Item ID: D206-642-341BL Accept ***N900040100*** Setup Start ***NS1***
 Revision ID: Stop ***NS2***
 Item Name: Replacement Skidtube (Fits LH or RH)
 Start Date: 1/28/2016 Start Qty: 1.00 ***1*** Cust Item ID:
 Required Date: 3/3/2016 Req'd Qty: 1.00 ***1*** Customer:
 Reference:

DRAWING NO. D2650	TITLE 206/407 SKIDTUBE ASSEMBLIES	REV. F	DART AEROSPACE LTD ENGINEERING ORDER		D.E.O. NO. D2650-F-1	SHEET NO. SHEET 1 OF 1	SCALE NTS
DRAWN [Signature]	CHECKED A.P.	MFG. APPR. [Signature]	APPROVED [Signature]		DE APPR. [Signature]		
DATE 12.10.12	DATE 12.10.22	DATE 12.10.22	DATE 12.10.22		DATE 12.10.22

CHANGE C'BORED WELDED CROSSBOLT SPACERS TO SWAGED SPACERS

DETAIL G

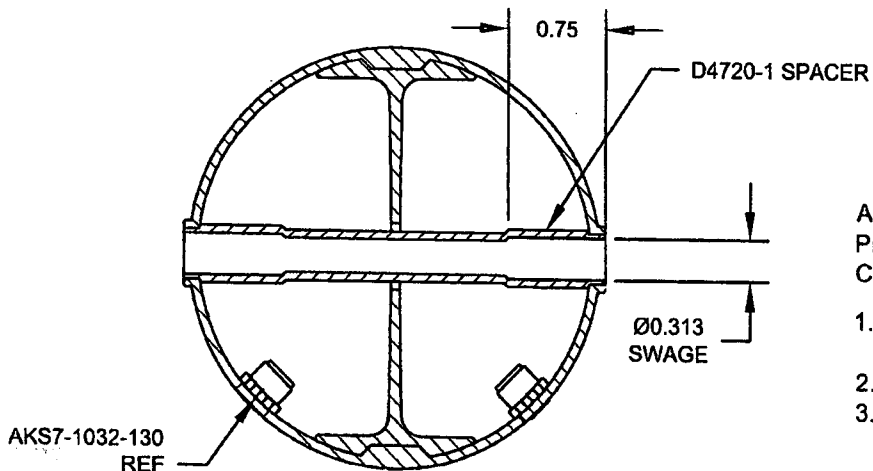
PARTS LIST IS AMENDED AS FOLLOWS:

IS:

QTY	QTY	QTY	QTY	PART NUMBER	DESCRIPTION
-1	-3	-5	-7		
1	1	0	0	D2649	CROSS BOLT SPACER
16	17	19	23	D4720-1	SPACER

WAS:

17	18	19	23	D2649	CROSS BOLT SPACER
----	----	----	----	-------	-------------------

ADD DETAIL G BELOW, WHICH IS THE SAME SECTION VIEW AS DETAIL D OF DWG.

C'BORED HOLES ARE **NOW SWAGED** PER DETAIL G BELOW. FOR THE Ø0.375 HOLE THAT IS NOT C'BORED, WELD PER DETAIL D OF DWG (SEE AMENDED DETAIL B FOR REFERENCE).

FOR Ø0.375 HOLES ONLY
FOR HOLES THAT ARE CURRENTLY C'BORED ONLY
NOT TO SCALE

D2649 SPACER,
WELD PER DETAIL D OF DWG
BUT DO NOT C'BORE

AFTER DRILLING AND BENDING ASSEMBLY
PERFORM THE FOLLOWING FOR Ø0.375 HOLES THAT ARE
CURRENTLY C'BORED:

1. INSERT D4720-1 SPACER, 16 PL (-1) OR 17 PL (-3)
OR 19 PL (-5) OR 23 PL (-7)
2. SWAGE TO Ø0.313 X 0.75 DP PER QSI 002
3. TRIM / GRIND FLUSH PER QSI 002
